Access Compliance Report

Public Rights-of-Way

(Curb Ramps)

Intersection ID: 3804	Main Street: MT_ISLE_HARBOR_DR	Cross Street: WRANGELL_LN	Location: W
ADA ID: 28CDA067B8B3	Ramp Type: BlendTrans1	Initial Pass/Fail: Fail	Overall Compliance: No
		Severity Score: 25

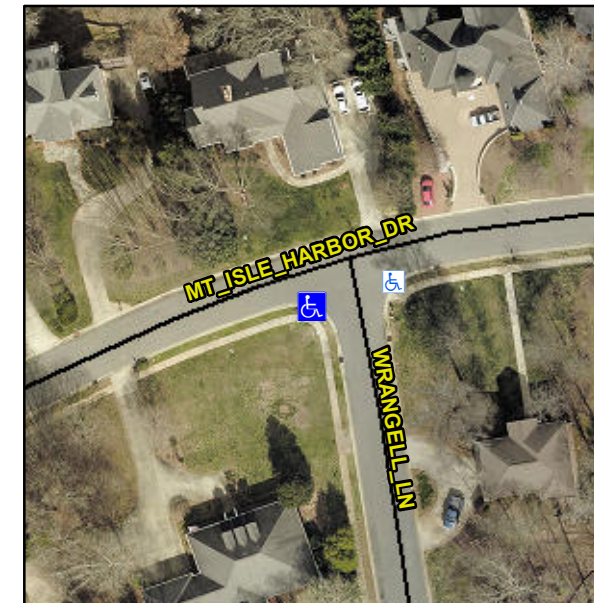
Not Found, R304.5.3

Compliance	Description	Data	Compliance	Description	Data
N/A	Ramp Length (in)	47.0	Yes	BlendTrans Slope (%)	3.2
Yes	Ramp Width (in)	50.0	No	BlendTrans XSlope (%)	7.5
N/A	Flare Type LT	N/A	N/A	Flare Type RT	N/A
N/A	Flare Slope LT (%)	N/A	N/A	Flare Slope RT (%)	N/A
N/A	Flare Traversable LT?	N/A	N/A	Flare Traversable RT?	N/A
N/A	Landing Length (in)	N/A	N/A	DWS Provided?	N/A
N/A	Landing Width (in)	N/A	N/A	DWS Contrast?	N/A
N/A	Landing Slope (%)	N/A	N/A	DWS Length (in)	N/A
N/A	Landing X Slope (%)	N/A	N/A	DWS Full Width?	N/A
N/A	Landing Curb? (Y/N)	N/A	N/A	DWS Offset (in)	N/A
N/A	Shared Landing?	N/A			
N/A	Gutter Ponding?	N/A	N/A	Gutter Slope (%)	N/A
N/A	Gutter Lip Ht (in)	N/A	N/A	Gutter X Slope (%)	N/A
N/A	Painted X Walk1?	No	N/A	Painted X Walk2?	N/A
	X Walk 1 Direction	To NE		X Walk 2 Direction	N/A
	X Walk 1 Width (in)	N/A		X Walk 2 Width (in)	N/A
	X Walk 1 Slope (%)	9.4		X Walk 2 Slope (%)	N/A
	X Walk 1 X Slope (%)	3.1		X Walk 2 X Slope (%)	N/A

N/A	Ramp inside XWalk1?	N/A	N/A	Ramp inside XWalk2?	N/A
	Road Slope (%)	3.1		Clear Space?	N/A
	Road X Slope (%)	9.4	N/A	Clear Space to XWalk (in)	N/A
N/A	Any Obstructions?	N/A	N/A	Storm Grate/Utility Hazard?	N/A
	Obstruction Type			Storm Grate/Utility Type	
		N/A			N/A
			Yes	Surface Condition? (G/P)	Good
			No	Curb Slope (%)	5.1

Remove & Replace Curb Ramp With Two New Directional Ramps or Equivalent.
